CP/MO
13176
24 July 2017

**SECTION 96(1A) MODIFICATION APPLICATION SSD-6011
SICEEP, DARLING SQUARE, SOUTH-WEST PLOT**

On behalf of Lendlease (Haymarket) Pty Ltd we hereby submit an application pursuant to section 96(1A) of the *Environmental Planning and Assessment Act 1979* (EP&A Act) to modify Development Consent SSD-6011 relating to the development of the South-West Plot in Darling Square, which is part of the Sydney International Convention, Exhibition and Entertainment Precinct (SICEEP) at Darling Harbour, Sydney.

Figure 2 – BMU access door details
Source: Lendlease

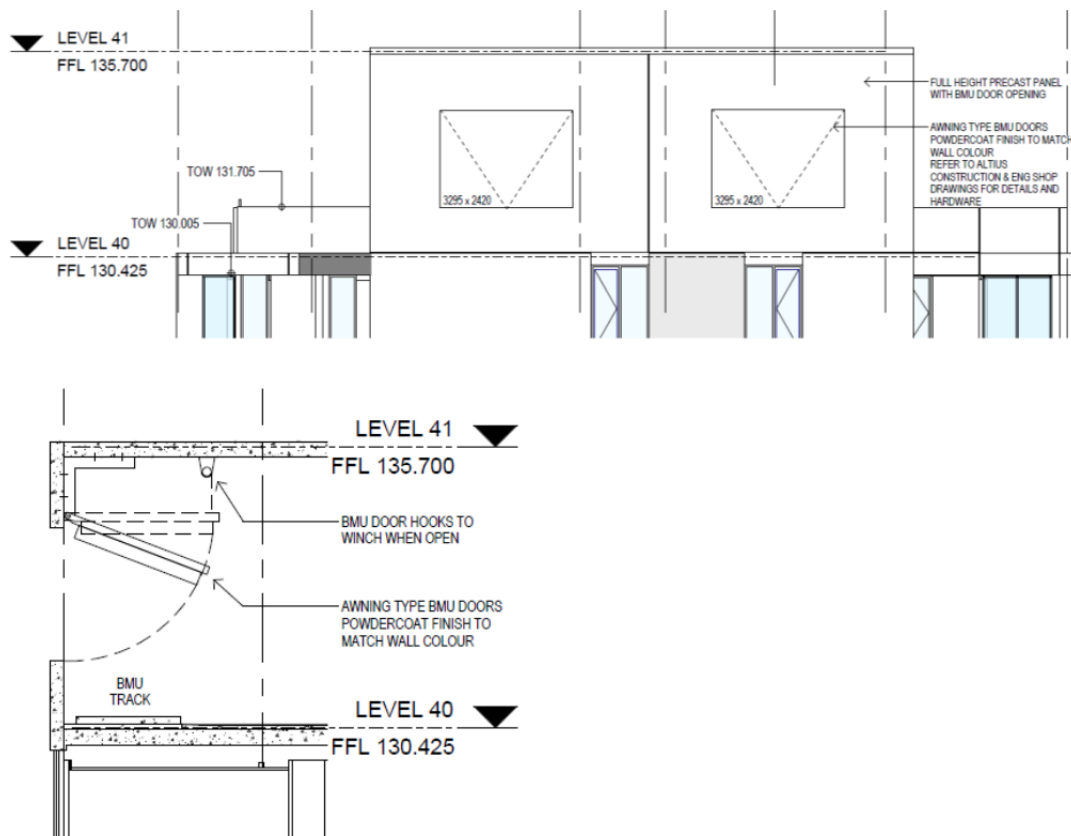
Inclusion of BMU access penetrations with infill doors to Level 40 of the SW3 Tower east and west facades (refer to Item 3 on DCM plans)

Due to safety requirements associated with cleaning and maintaining the eastern and western elevations of SW3 (the 40-storey tower component of the South-West Plot), rope access to building facades is not possible and a BMU is required to service these façade to avoid the danger of abseiling from this height. When in operation the BMU unit will extend through the façade from Level 40 via operable access doors that will only open when the BMU is periodically in use. These doors will be engineered to sit immediately flush against the façade and be colour matched to surrounding finishes to ensure a consistent and architecturally seamless façade. **Figures 2 and 3**, which provide details of the doors for when the BMU is both operational and in-active, reinforce the strategy to sensitively integrate this functional requirement of the building.

The proposed BMU access penetrations will have minimal impact upon the architectural form and character of the approved building, with the colour of the access doors to be closely matched in colour and form to the adjoining façade so as to be largely imperceptible when viewed externally. It is noted that the doors would be located at Level 40, more than 100 metres above existing ground level, and would therefore be some distance away in public views toward the building. Use of the BMU, requiring the opening of these doors, would be infrequent and is a normal part of building maintenance, and would have no adverse built form or architectural impact on the approved development.

Figure 3 – Proposed furniture and artwork at the interface of SSD-6013, Steam Mill Lane

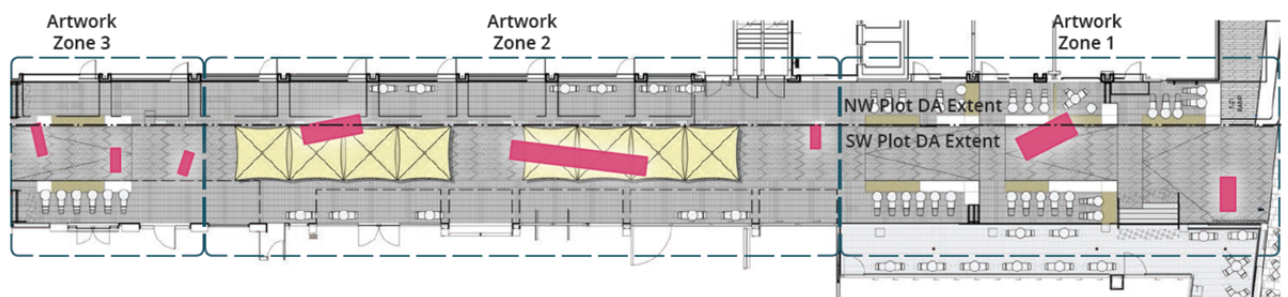
Installation of fixed and moveable furniture proposed in Steam Mill Lane

A combination of fixed and moveable furniture is proposed to be installed at the edges of the terraces. The fixed components will comprise low seating with stone and timber elements. The moveable elements will support retailers to trade out from their tenancies. The proposed fixed furniture layout within the South West Plot is shown in **Figures 3 and 4**.

Installation of catenary public art in Steam Mill Lane

An integrated light-based artwork with several individual pieces is proposed to be installed within Steam Mill Lane as catenary lighting. Each piece will have the appearance of abstract signage during the day, and neon lights at night. The artwork is to be sensitive to the character of three distinct zones that differ in terms of scale, shape, size, character and intended viewing position. The majority of artwork installations are proposed predominantly within the South West Plot, with only portions of some of the works entering land comprising the North West Plot. The location of the artwork zones and indicative positioning of each of the artworks within the two plots is shown in **Figure 3**.
